ADDENDUM NO. 1

Oak Hill Jr. High Roof Replacement and Oak Hill High School MEP Upgrade
Jr. High - 7760 W. Delphi Park – 27
High Sch. - 7756 W. Delphi Park – 27
Converse, IN 46919

Addendum One (AD.01) to the drawings and specifications prepared by Gibraltar Design for **Oak Hill Jr/Sr High School Roof Replacement Oak Hill Senior High School Pool Equipment Replacement** for Oak Hill United School Corporation, Converse, Indiana.

2. Sheet A-210

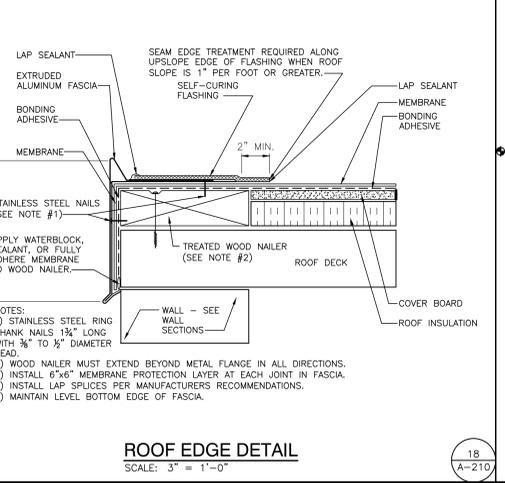
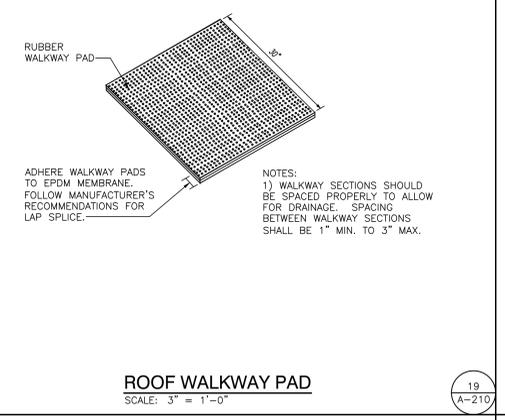
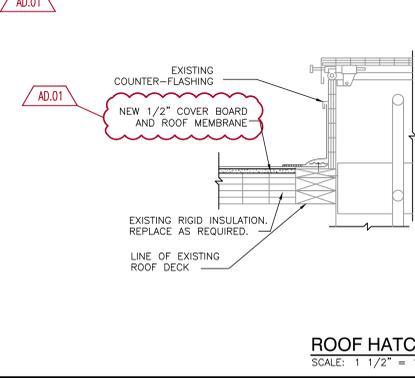
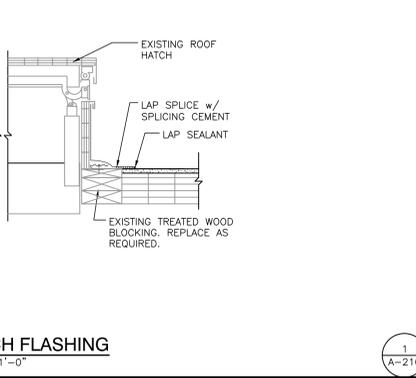
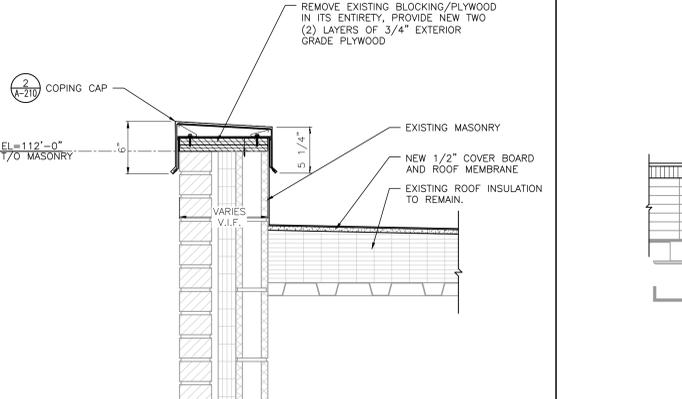
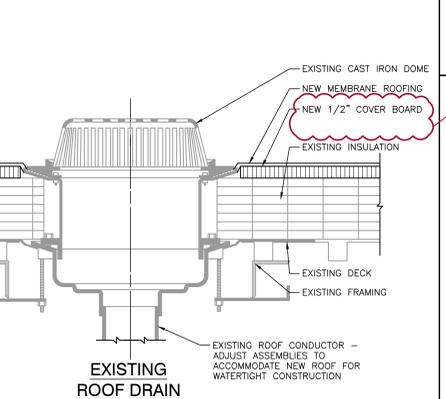
- A. Changed reference of existing cover board to new ½" cover board on Details 1/A-210 and 10/A-210.
- B. Removed membrane lining in gutter on Detail 17/A-210.
